**ADDENDUM NO. 2**

**WWTF ALUM RESIDUAL LAGOON MODIFICATIONS  
ROCHESTER, NH**

**OCTOBER 28, 2010**

**PREPARED BY:  
WRIGHT-PIERCE ENGINEERS  
230 Commerce Way, Suite 302  
Portsmouth, NH 03801  
Tel. 603-430-3728  
Fax 603-430-4083**

## LAGOON BERM DETAIL

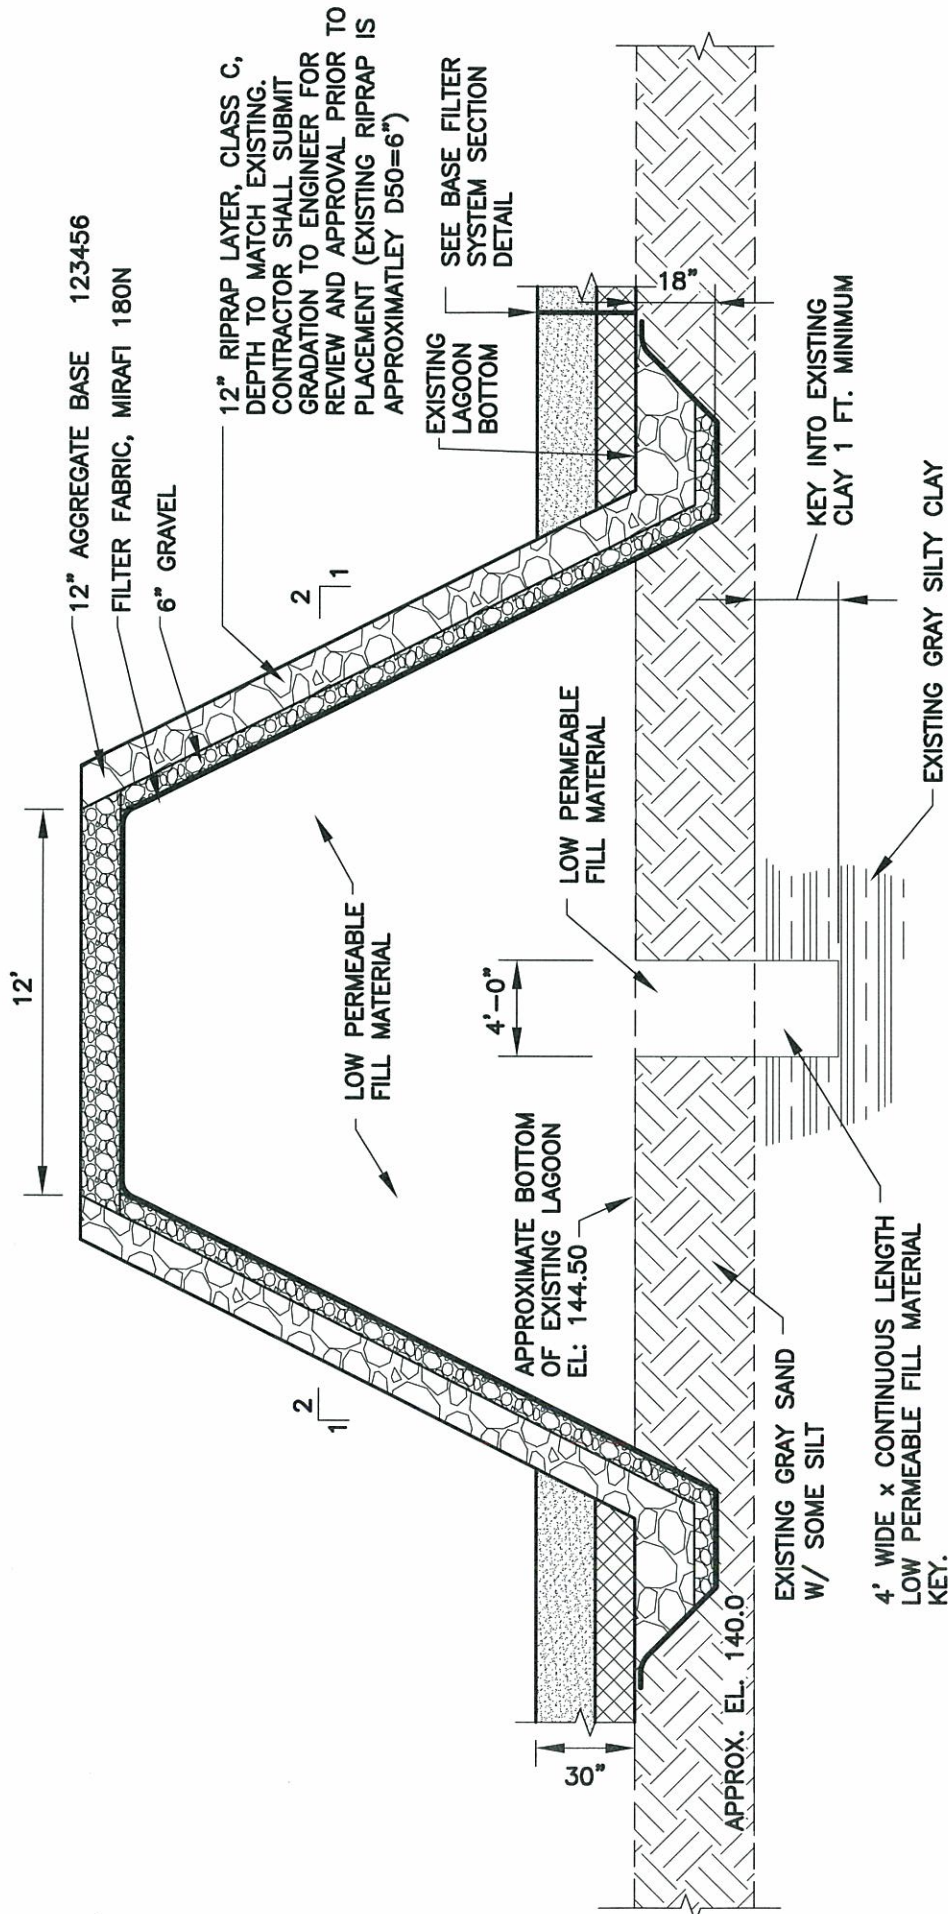
1. On sheet C-13, **DELETE** "Lagoon Berm Detail" located in upper left hand corner **ADD** "Lagoon Berm Detail" as per attached. In addition to adding an impervious key, on this detail 6" crushed stone changed to 6" gravel.
2. On sheet PR-1, Alum Sludge Decant Pump Chambers B and C; In section views, Left Hand Slide Gate is removed, Middle Slide Gate is reconstructed as a downward opening weir gate, Right Hand Slide Gate to remain "as is".
